UNITED STATES PATENT AND TRADEMARK OFFICE

APPLICATION NO.	FILING DATE	FIRST NAMED INVENTOR	ATTORNEY DOCKET NO.	CONFIRMATION NO.
10/718,514	11/24/2003	Kenneth Gordon Walker	W245 0004	1974
720	7590	08/15/2006	EXAMINER	
OYEN, WIGGS, GREEN & MUTALA LLP			BOGART, MICHAEL G	
480 - THE STATION			ART UNIT	PAPER NUMBER
601 WEST CORDOVA STREET				
VANCOUVER, BC V6B 1G1			3761	
CANADA

Office Action Summary	Application No.	Applicant(s)	
	10/718,514	WALKER, KENNETH GORDON	
	Examiner	Art Unit	
	Michael G. Bogart	3761

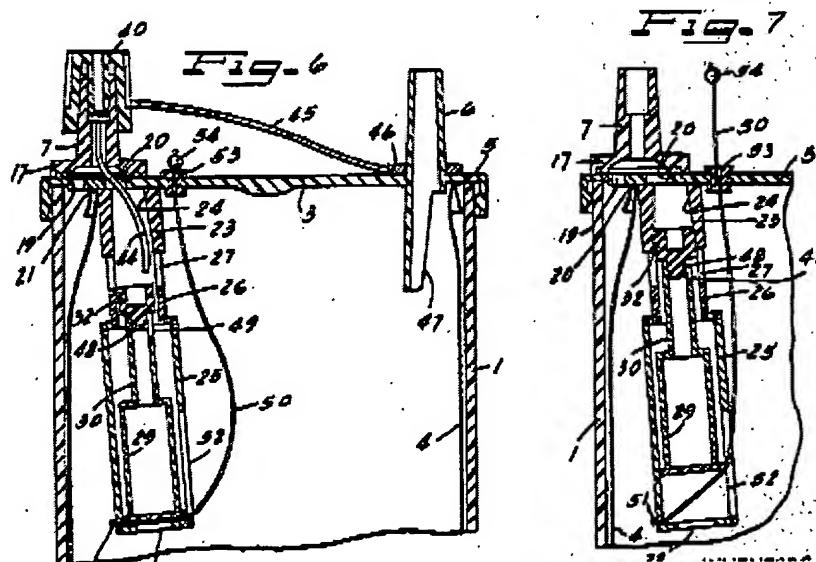
Claim 3 is rejected under 35 U.S.C. § 102(b) as being anticipated by Hallsworth *et al.* (US 4,246,676; hereinafter “Hallsworth”).

Hallsworth teaches a check valve (48) for a canister (12) adapted to receive fluids, said canister (12) having a vacuum port (40) for application of vacuum to said canister (12) for inducing a flow of fluids into said canister (12), said check valve (48) being operably coupled to said vacuum port (40) for stopping said application of vacuum to said canister (12) when said fluids in said canister (12) reach a pre-determined level upper, said check valve (48) comprising:

(a) a floatball (54) operatively coupled to a needle valve (56, 48); said floatball being positioned below said needle valve (56, 48) to lift said needle valve upwardly to effectively stop the vacuum applied to the vacuum port when said fluids reach said upper level; and

(b) a needle valve (56, 48);
(c) a floatball cage (50) for housing said floatball (54), said floatball cage comprising a needle valve guide (62) for slidably retaining said needle valve (56, 48)(col. 3, lines 22-64)(see figure 2, infra).
